FINAL SITE CLOSURE REPORT

FORMER CONSTRUCTION DEBRIS LANDFILL #4

**CAMP NAVAJO
BELLEMONT, ARIZONA**

COMMENTS AND RESPONSES

Figure 1-2

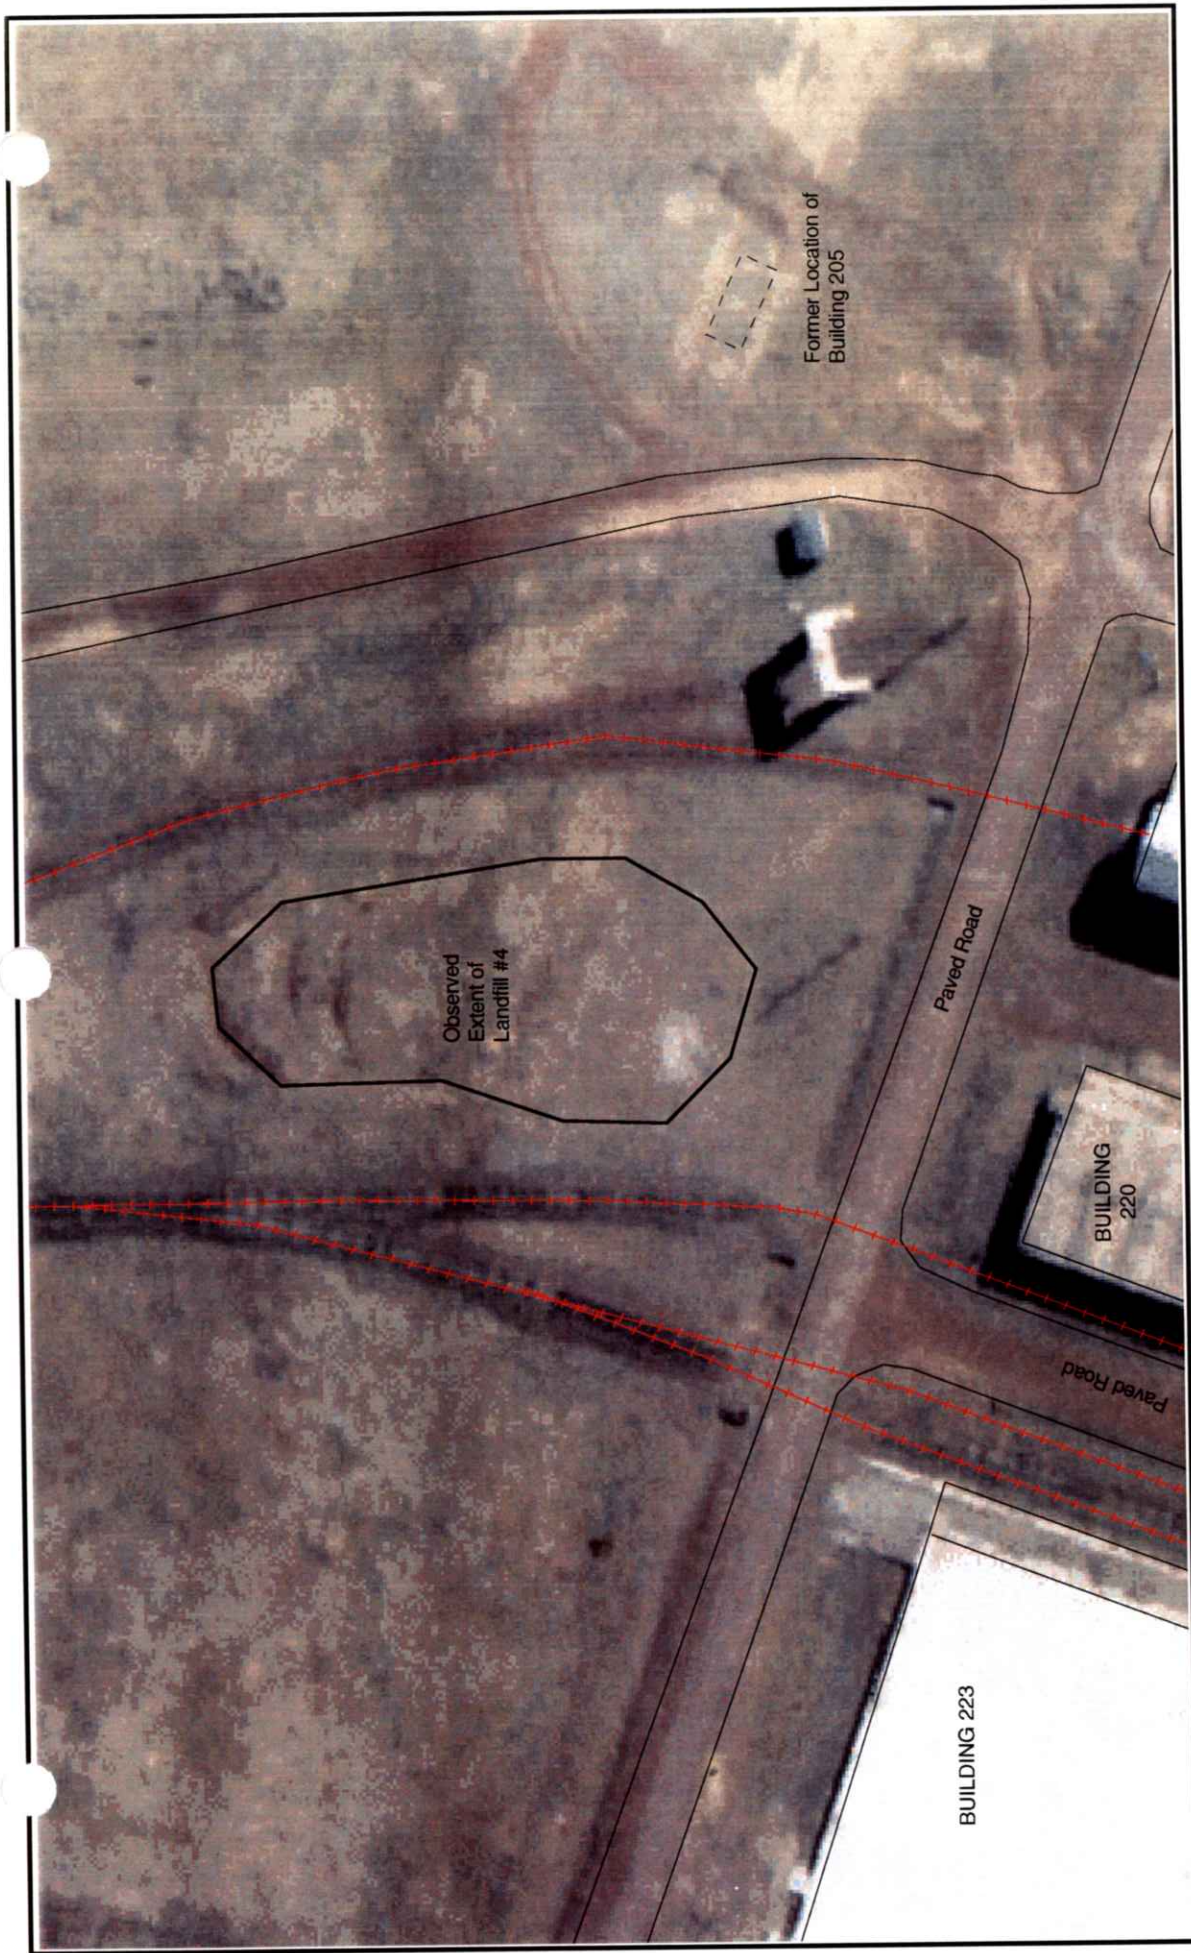
Figure 1-2 Indicate (arrow) site location	Will be revised in final.

Figure 2-1

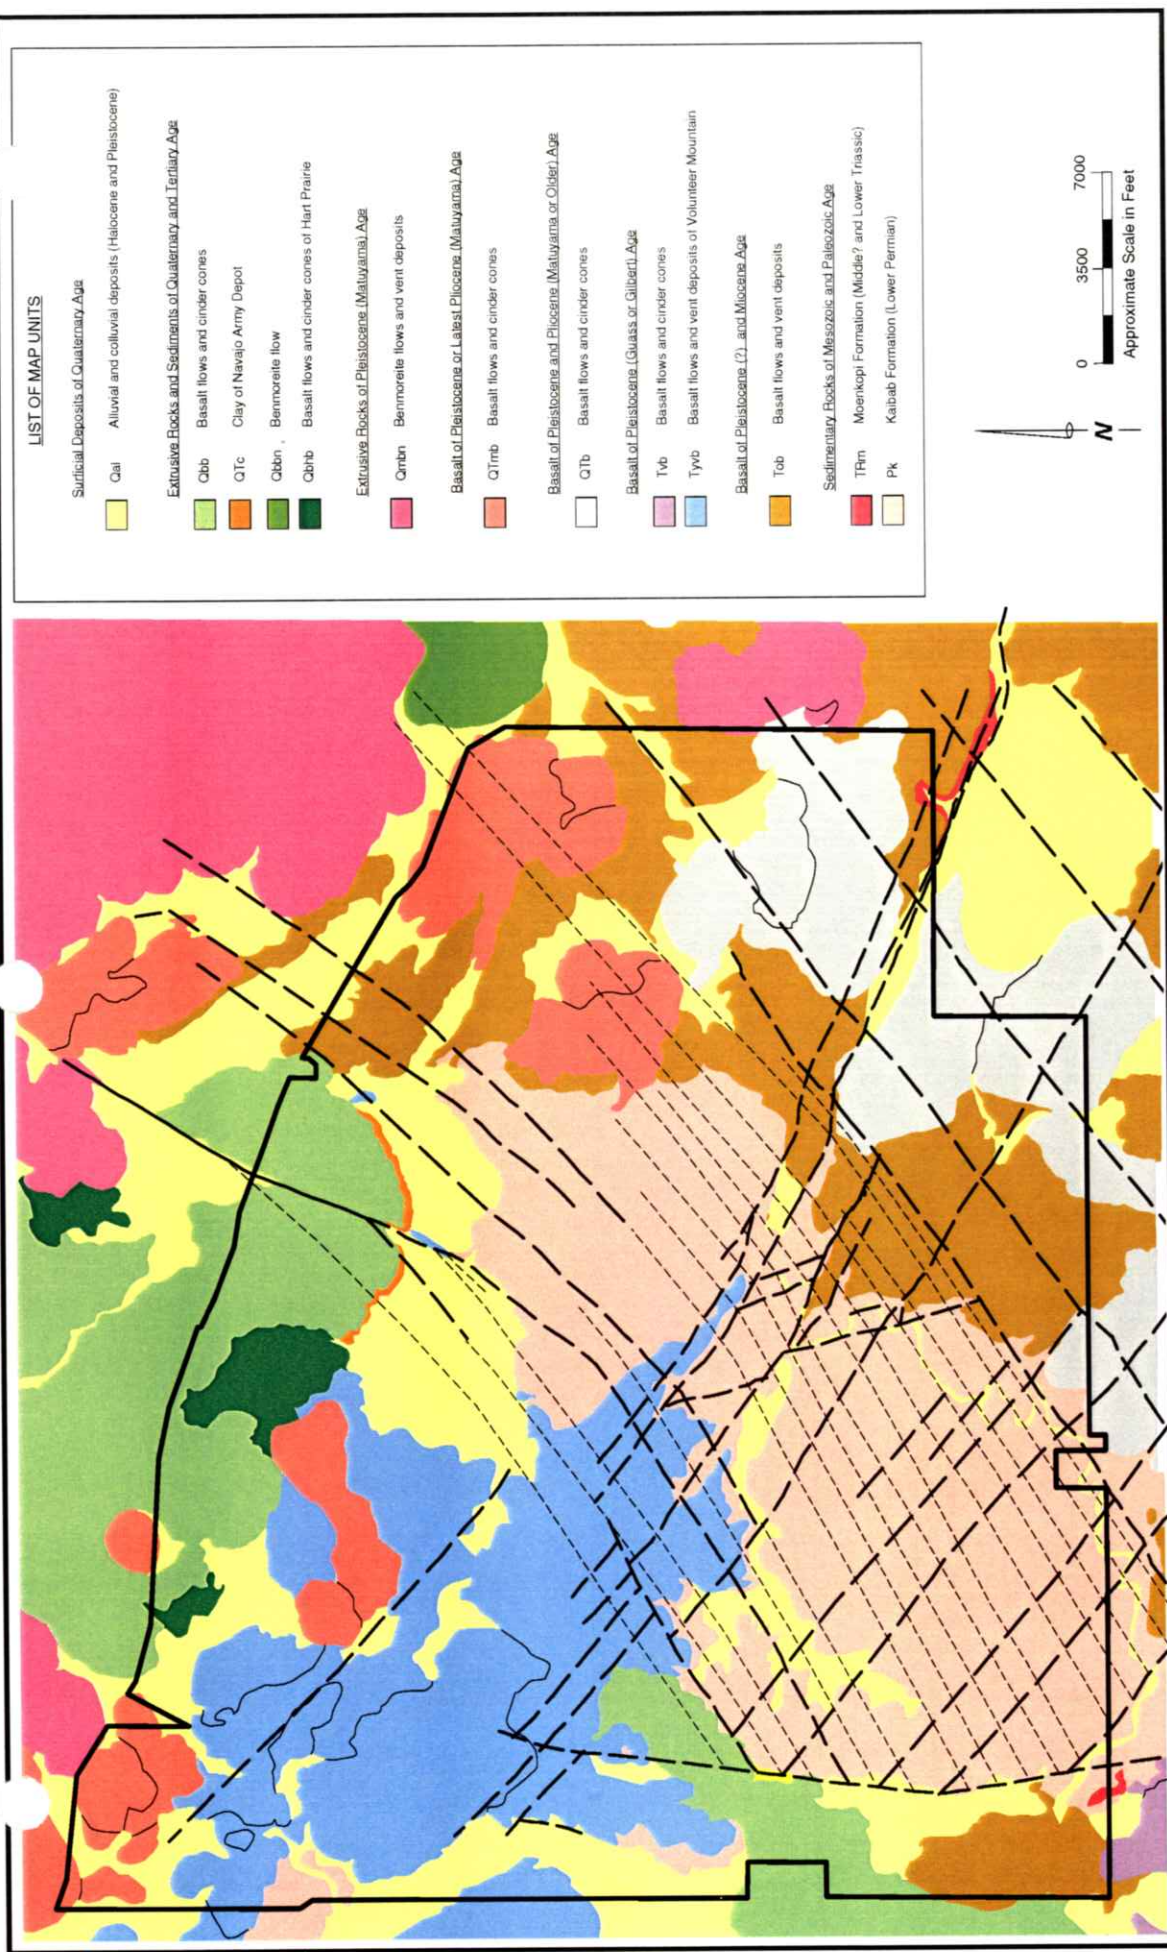
Comment	Response
Section 2.2. Figure 2-1; In the older February and March reports this map has one area of alluvium along the northern boundary that is shaded as basalt. In the newer November report two more areas (along eastern boundary and along Dunham fault) are incorrectly shaded. The blatant statement regarding faults as conduits on the older maps is made palatable by the addition of "potential" on the newer version, but would probably be best if deleted entirely. Also on the November report, the legend contains incorrect symbols for the railroad and suspected fault. Personally, I liked the geologically meaningful rock symbols of the older map better than the hatchured symbols of the newer map.	Figures in all closure reports will be revised to be clear and consistent.
Section 2.3. Paragraph 3; The water table is 200 feet below the top of the Supai Formation, and is not within the strata commonly assumed to be the aquifer in the Flagstaff area. Please revise this statement to reflect actual conditions below the Base. There is no justification for the statement regarding declining water levels. Only a handful of measurements exist, some of which are dubious. However, consider the following observations. Water levels since 1977 have remained higher than the 1369 feet measured then. Water levels measured during 1996 ranged from a low of 1343 (Tetra Tech) in January to a high of 1303 (USGS) in August, after a drought winter. Another 30 feet of rise is entirely conceivable in a wet year. Please remove your statement. See the comments for the Deep Well Report for further discussion.	Text will be revised in final.

Comment	Response
Figure 2-1: Remove paragraph on faults as conduits	Will change text to say that a fault is a potential conduit.
Signature block: Please add Mr. Aala's title	Will be revised in final.
Appendix A: Are color photos available?	Color photos will be printed in final report.
Section 1.2. 1st paragraph, last sentence; rewrite as follows: ...for the storage of ARNG material and munitions, and the United States Air Force...	Will be revised in final and will also include US Navy.
Include reference to Uribe & Associates VSI report for USEPA/ADEQ: RCRA Facility Assessment Report, 1994, prepared for Region 9 United States Environmental Protection Agency	Will be revised in final.
Section 2.4. 1st paragraph, 1st sentence: strike approximately	Will be revised in final.
Section 1.1. Add reference to NADA and AREE numbers/designations to tie to historic documents and to regulatory listings	Will be revised in final.
